# UNITED STATES PATENT AND TRADEMARK OFFICE

APPLICATION NO.	FILING DATE	FIRST NAMED INVENTOR	ATTORNEY DOCKET NO.	CONFIRMATION NO.
10/695,377	10/27/2003	Thomas Wesley Melcher	MELC-10122	5310

<b>Office Action Summary</b>	<b>Application No.</b> 10/695,377	<b>Applicant(s)</b> MELCHER, THOMAS WESLEY	
	<b>Examiner</b> Eric Culbreth	<b>Art Unit</b> 3616

# Replacement Sheet

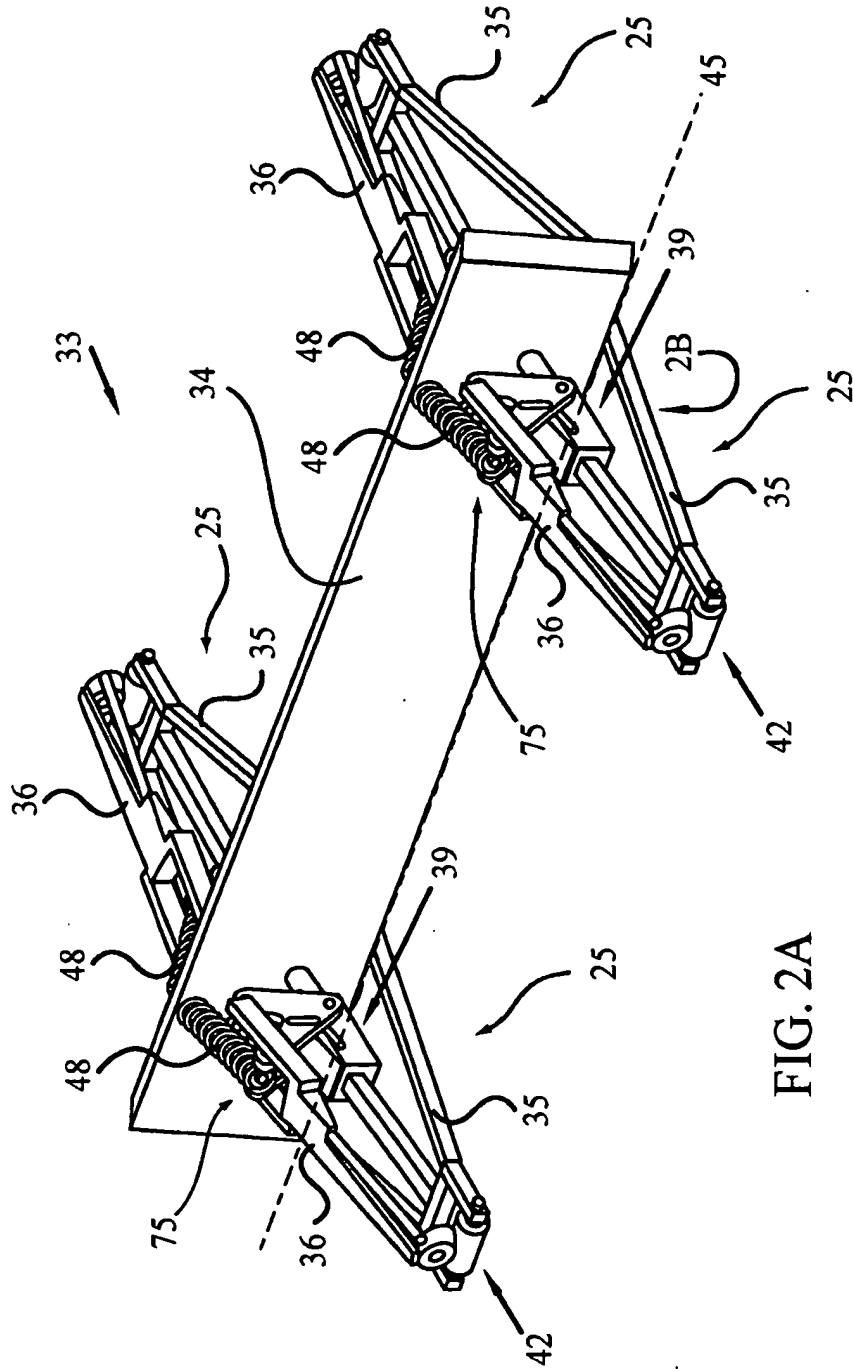
1. The drawings were received on 11/16/05. These drawings are not approved. The arrows on both ends of every line of the diagram in Figure 8 would result in new matter. While the specification mentions a feedback system, this is not support of each part having feedback to the processor and for the processor feeding signals to every part in Figure 8.
2. Because the replacement drawings were not approved, the other objections raised to the drawings in paragraph 2 of the first Office Action mailed 5/11/05 remain.
3. The drawings are objected to under 37 CFR 1.83(a). The drawings must show every feature of the invention specified in the claims. Therefore, the features of claim 21 (feedforward by a shock absorber) must be shown or the feature(s) canceled from the claim(s). No new matter should be entered.

*Not Approved*  
*EL*  
*2/3/06*

Corrected drawing sheets in compliance with 37 CFR 1.121(d) are required in reply to the Office action to avoid abandonment of the application. Any amended replacement drawing sheet should include all of the figures appearing on the immediate prior version of the sheet, even if only one figure is being amended. The figure or figure number of an amended drawing should not be labeled as "amended." If a drawing figure is to be canceled, the appropriate figure must be removed from the replacement sheet, and where necessary, the remaining figures must be renumbered and appropriate
